CRG Mining LLC  
510 S. Wisconsin St.  
Gunnison, CO 81230  
March 4, 2020

Re: Raymond Mine, File M-2020-013, 110(2) Permit Application, Adequacy Responses

We are responding to your adequacy review letter, dated February 24, 2020, for the above-named permit application. The numbered items below refer to the respective items contained in your letter.

**GEOLOGIC MAP OF THE GOLD BRICK MINING DISTRICT, COLORADO**

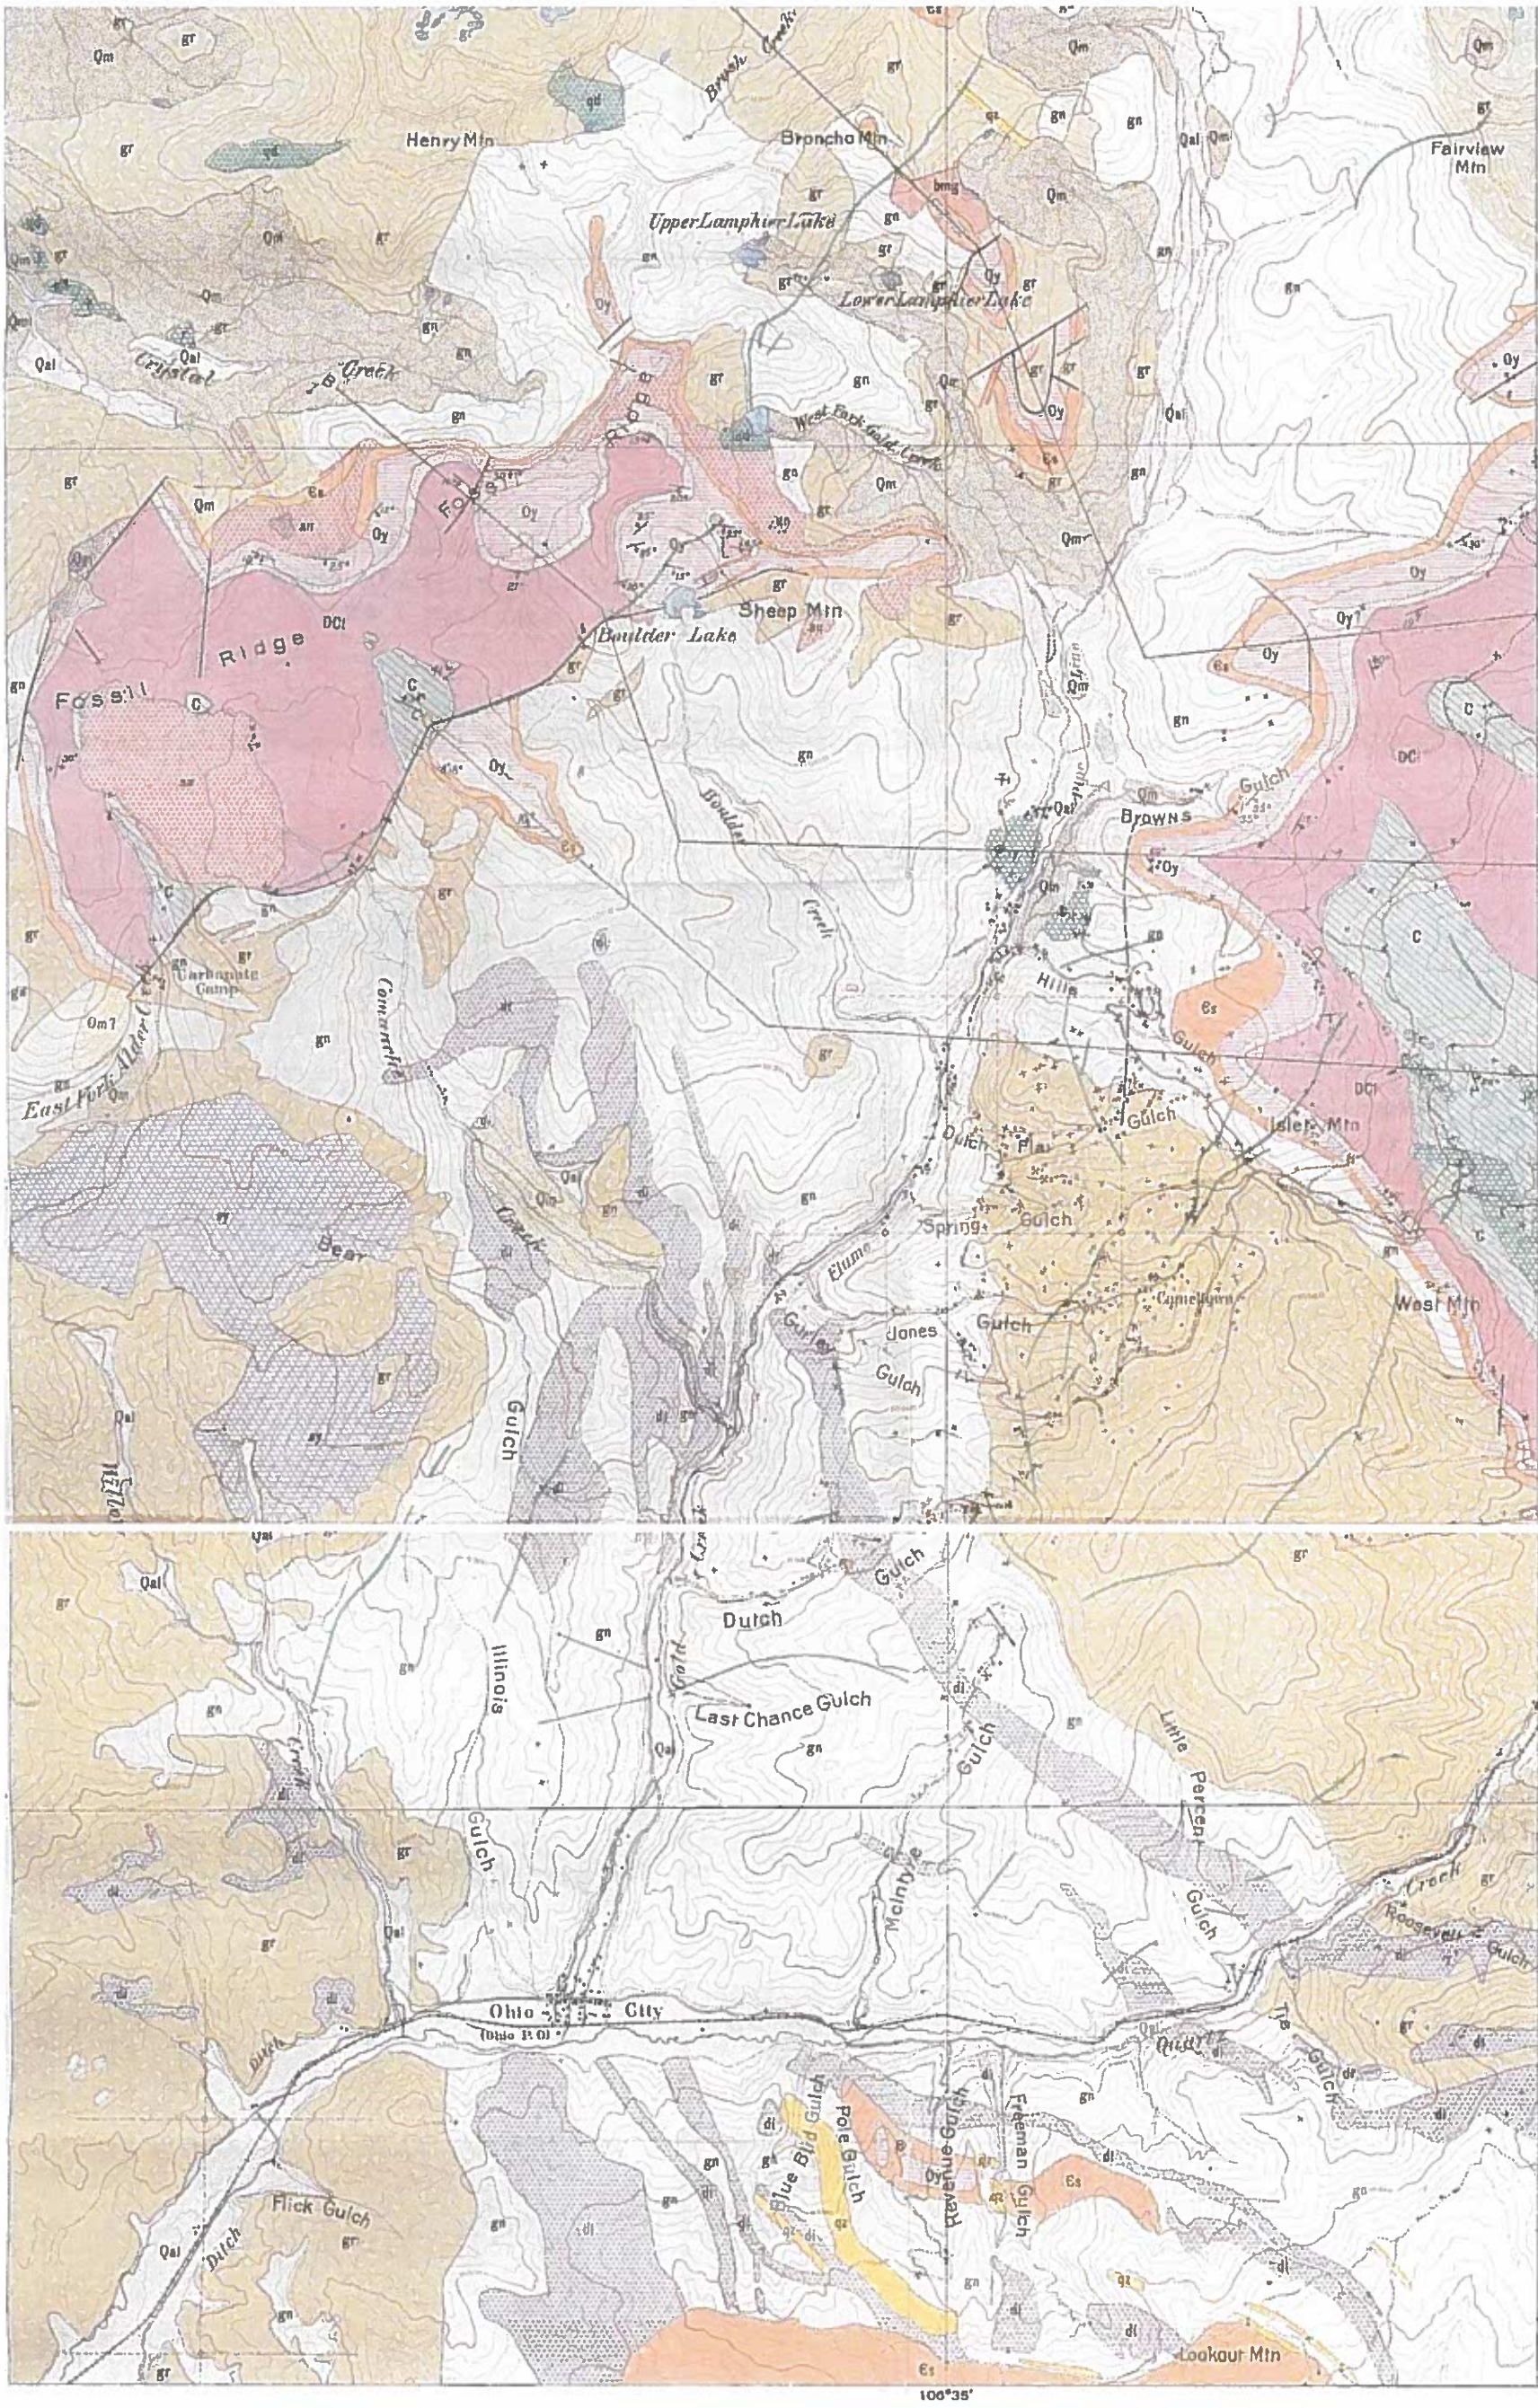
4. We do not have analysis of the rock yet. Though the site is currently under snow, it is accessible and we will take representative samples in the next few days and send them to be analyzed. Tests will consist of SPLP (synthetic precipitation leaching procedure) and ABA (acid-base accounting). Upon receiving results, they will be forwarded to you promptly. Since the country rock in this area is extensive and uniform, only one sample will be collected. Please see the attached "Gold Brick Mining District Geology Map" file showing the area's lithology. (The area subject to this application is north of Ohio City on Gold Creek, and eastward up Jones Gulch and Spring Gulch.) The rock types in the zone of our proposed operation are identified as "biotite granite, common types" and "mainly gneisses and schists with a small quantity of quartzite." These descriptions support our statement that the rock is benign and uniform.
